APPLICATION FOR PERMISSION UNDER SECTION 16 OF THE TOWN PLANNING ORDINANCE (CAP. 131)

For Official Use Only 請勿填寫此欄	Application No. 申請編號	A/16-KTS/1071
	Date Received 收到日期	2025-05-2-

(a) Proposed use(s)/development 擬議用途/發展	Proposed Temporary Warehouse (Excluding Dangerous Goods Godown) with Ancillary Facilities and Associated Filling of Land for a Period of 3 Years 擬議臨時貨倉（危險品倉庫除外）連附屬設施及相關的填土工程（為期3年） (Please illustrate the details of the proposal on a layout plan) (請用平面圖說明擬議詳情)
(b) Effective period of permission applied for 申請的許可有效期	<input checked="" type="checkbox"/> year(s) 年 3 <input type="checkbox"/> month(s) 個月

Planning Application No. A/YL-KTS/1071

補充說明

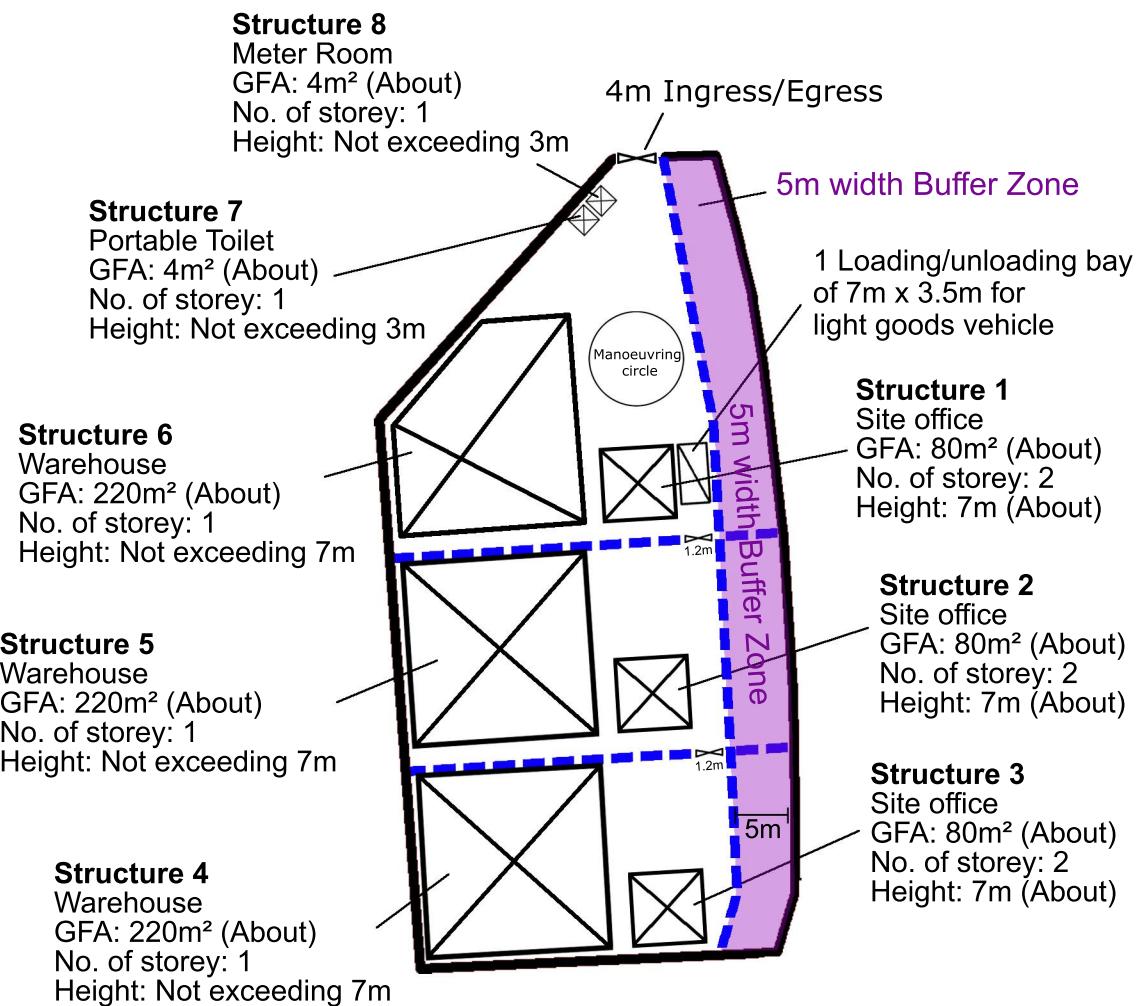
Departmental Comments	Responses
	Planning Department	
(a)	Please confirm that “no dangerous goods will be stored at the Site. No open storage, assembling, dismantling, maintenance and other workshop activities will be conducted within the Site”.	申請人確認擬議申請的臨時貨倉並不會存放任何危險物品，也不會在現場進行露天存放、修理、組裝、拆卸或工場活動。
	Please confirm that all activities would only be carried out within the application site.	申請人確認所有活動只會在申請範圍內進行。（Layout Plan 上的黑色線範圍內）
	According to the site photos taken, it is noted that fences are erected along the boundary of the application site. Please advise that they should be clearly marked on the layout plan.	請查看附件 1。 黑色粗線就是申請範圍的圍板位置。

1. 申請地點只設一個大門給貨車和職員進出，緩衝區內（Buffer Zone）不會有任何卸貨活動或職員進出，確保達到緩衝效果。
2. 申請地點內 3 個貨倉是可以互通的，職員可透過中間的小門用手推車送貨。
3. 擬議申請的申請地點早前已獲批准做動物寄養所，但由於元朗廈村及洪水橋近期被政府徵收土地，大量貨倉被逼遷出和要找地方搬，貨倉需求大大提升，因此申請人將擬議申請用途轉成臨時貨倉，以應付貨倉需求急升和回應政府政策。

Appendix C - Drainage Plan

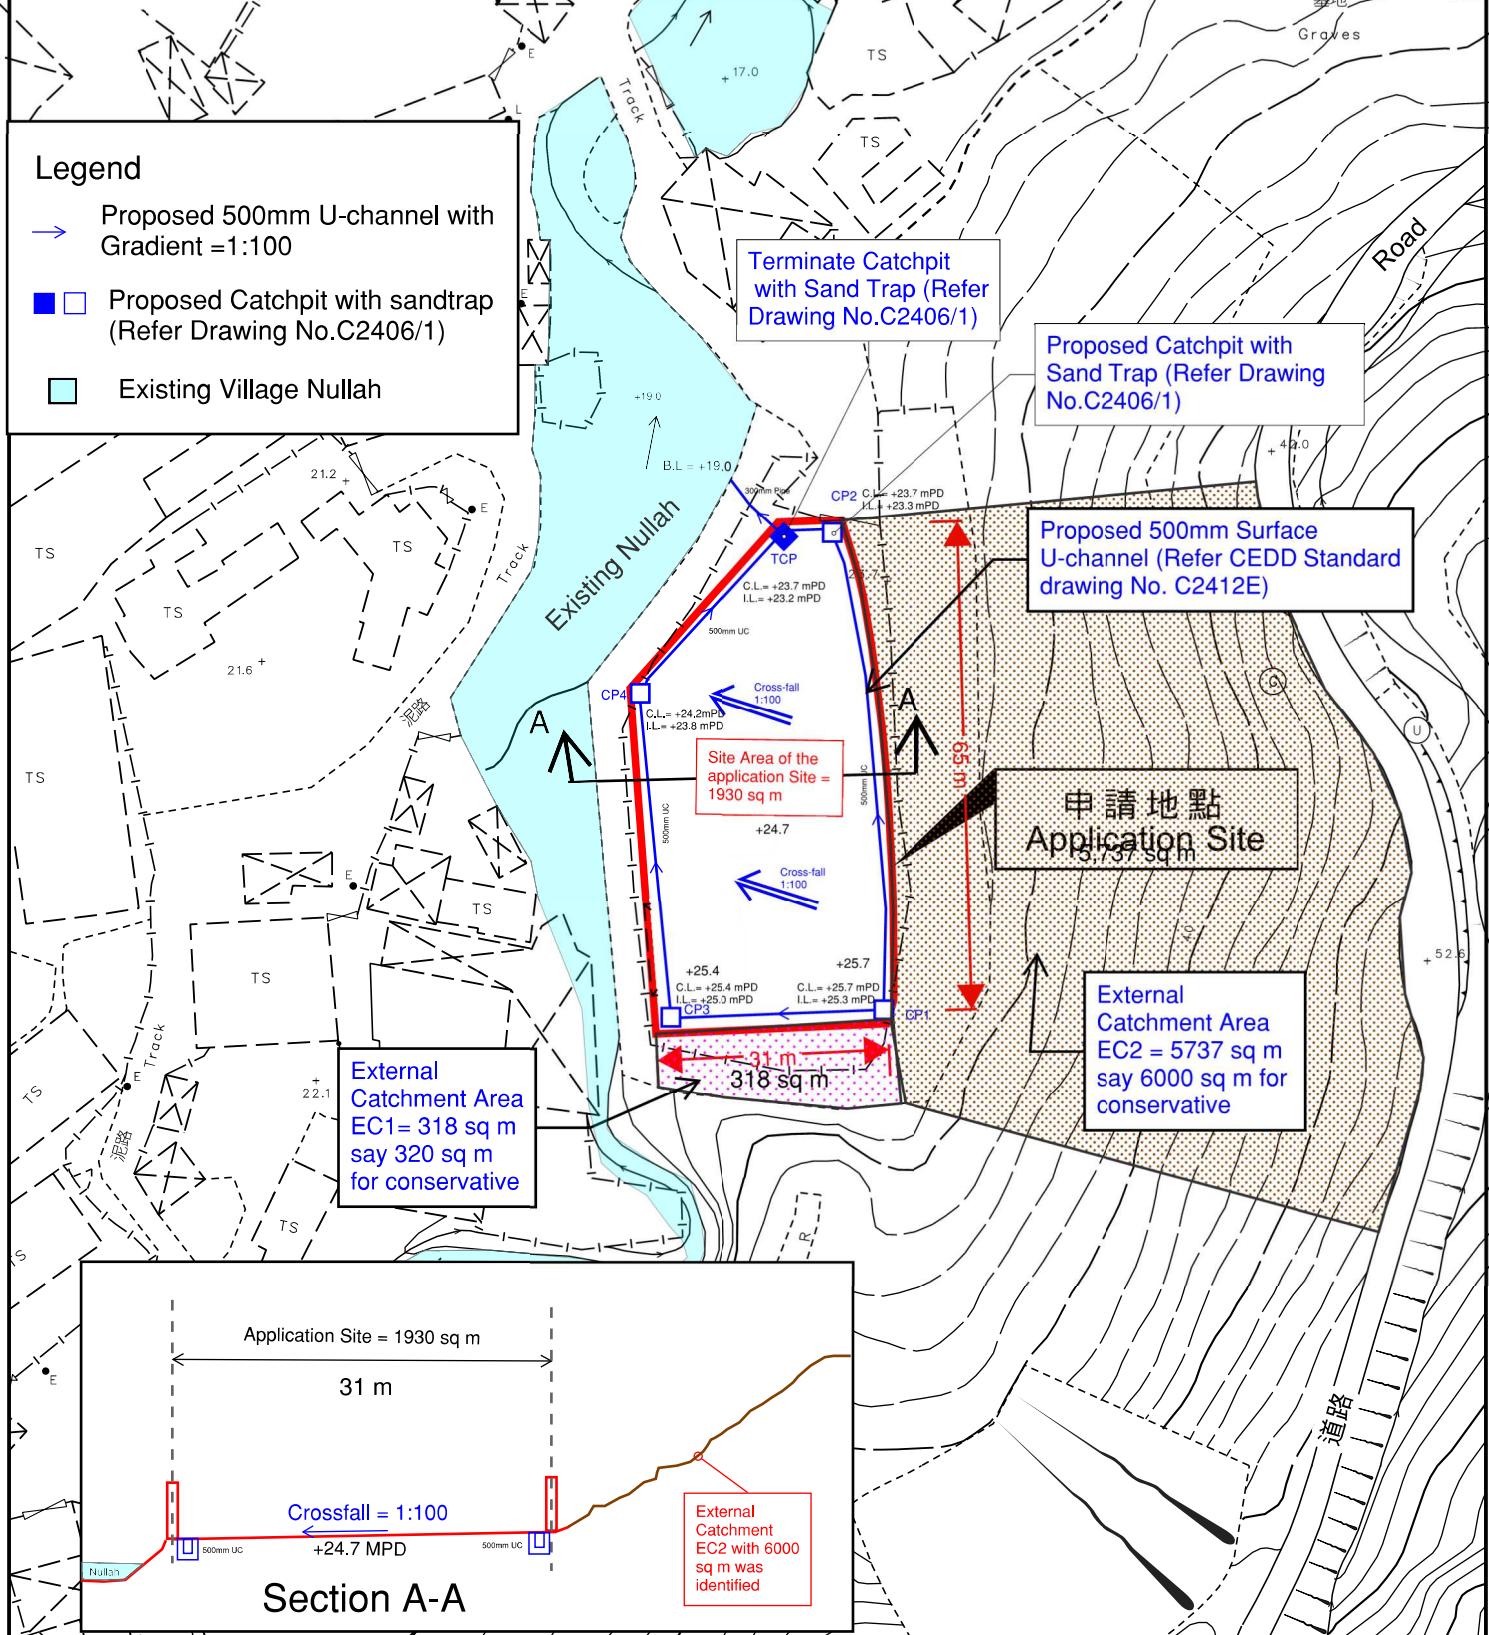
No.	Comments	Response
1.	Please include the connection details, including the C.L., I.L. and B.L., at discharge point in the submission.	Please refer to the revised Appendix C – Drainage Plan.

2.	For ease of reference, please include a drainage schedule in the submission	Please refer to the revised Appendix C – Drainage Plan.
3.	Cross sections at longitude direction showing the existing and proposed ground levels of the captioned site with respect to the adjacent areas should be given.	Noted and provided. Please refer to the revised Appendix C – Drainage Plan.

4.	Please revise the catchment area and take into account the overland flow from the adjacent hilly terrain in the drainage proposal assessment.	The overland flow from the adjacent hilly terrain is incorporated as the external catchment. Please refer to the revised Appendix C – Drainage Plan.

5.	Storm constants for different return period of HKO Headquarters should be adopted for the design calculations.	Noted and revised.
6.	Cross section A-A revealed that the proposed channel cannot intercept the overland flow from the adjacent lands, please review the C.L. of the proposed channels.	Cross section A-A is provided. Please refer to the revised Appendix C – Drainage Plan.

7.	400mm peripheral u-channel is proposed for the application site. However, the size of the proposed downpipe is 200mm. Please review and include the design calculation of the proposed downpipe in the submission. The velocity of proposed downpipe should be checked.	Noted and revised. Please refer to the revised Appendix C – Drainage Plan and the Appendix D- Design Calculation.

圖 1

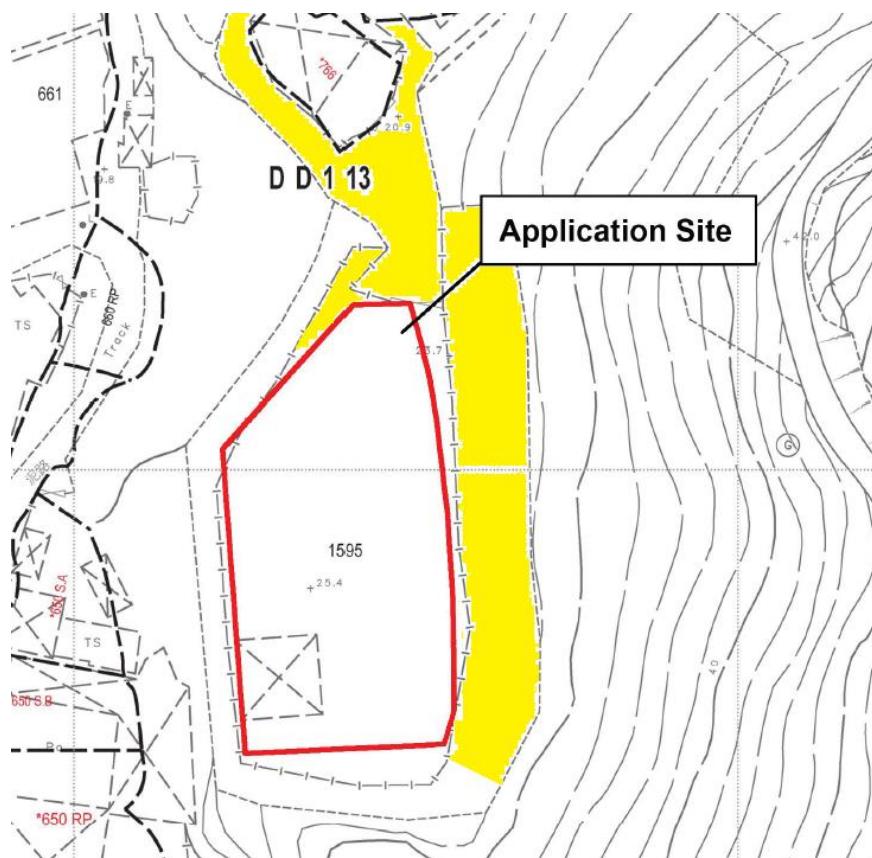
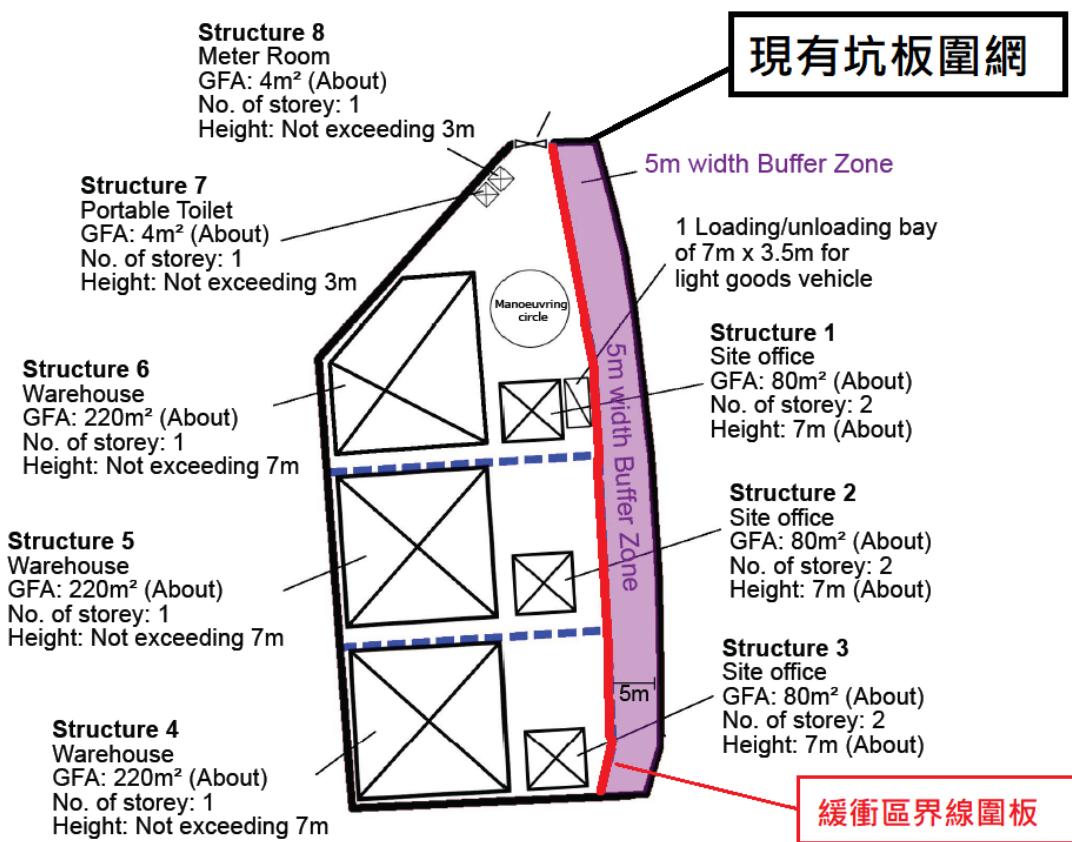
Departmental Comments	Responses
	Planning Department	
(a)	For the proposed 5m buffer zone, please provide justifications for the fencing to be proposed a) along the eastern application boundary and b) between the proposed use and proposed 5m buffer zone.	由於申請地點附近的政府土地（圖 1：黃色部份）已被人蓄意破壞和非法佔用，申請人不能把申請地點（屬於私家地及申請範圍）的現有坑板圍板拆除。但申請人會在 5 米的緩衝區地界再設置新的圍板，高度約 1.8 米，請看圖 2。
(b)	Please clarify and ensure proper maintenance of the proposed fencing, that no activities and storage should be conducted within the 5m buffer zone.	申請人確認會在 5 米的緩衝區地界設置新的圍板（圖 2 紅色部份），並會好好嚴格管理緩衝區，不會有任何露天儲物的活動。

Table A: Responses to Departmental Comments

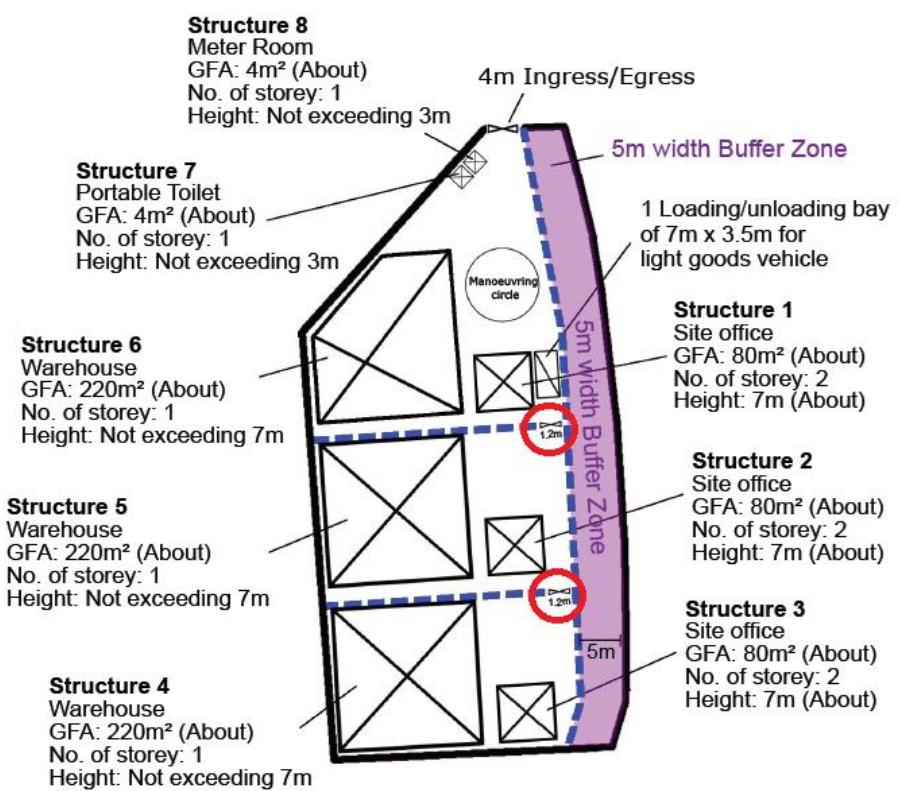
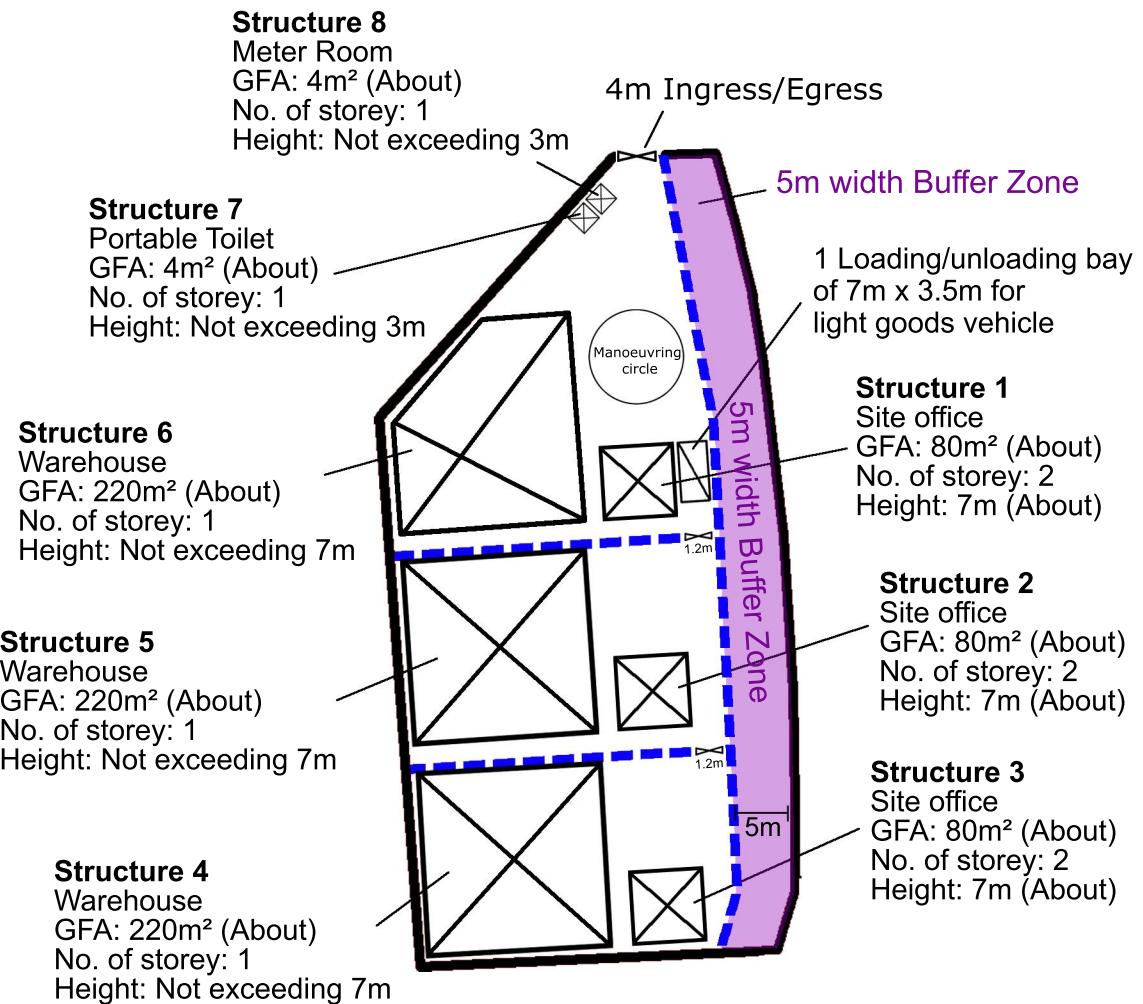
Departmental Comments	Responses
	Planning Department	
(a)	<p>Please clarify whether the proposed buffer zone of 5m is currently land filled. If so, please propose when suitable measures would be undertaken to rectify.</p>	<p>申請地點的 buffer zone 已進行填土。</p> <p>申請人會移除緩衝區的填土物料，以保護緩衝區不受破壞。</p> <p>現時 Buffer Zone 內沒有任何東西或圍板，而且不會在 Buffer Zone 內進行任何活動。</p> <p>附件 1：Revised Layout Plan</p>
(b)	<p>As shown in the latest site layout plan of the FI 3 submitted on 3.9.2025, there is no vehicular access to Structures 2-5. Please clarify on the logistics arrangement and revise the plan suitably.</p>	<p>新的 Layout Plan 上面，紅色部份為 1.2 米的 4 呎闊行人出入口。</p> <p>構築物 2-5 的貨品，可在臨時上落貨車位進行上落貨，然後用手推車/唧車/電唧車穿過紅色的出入口安排送貨。</p>
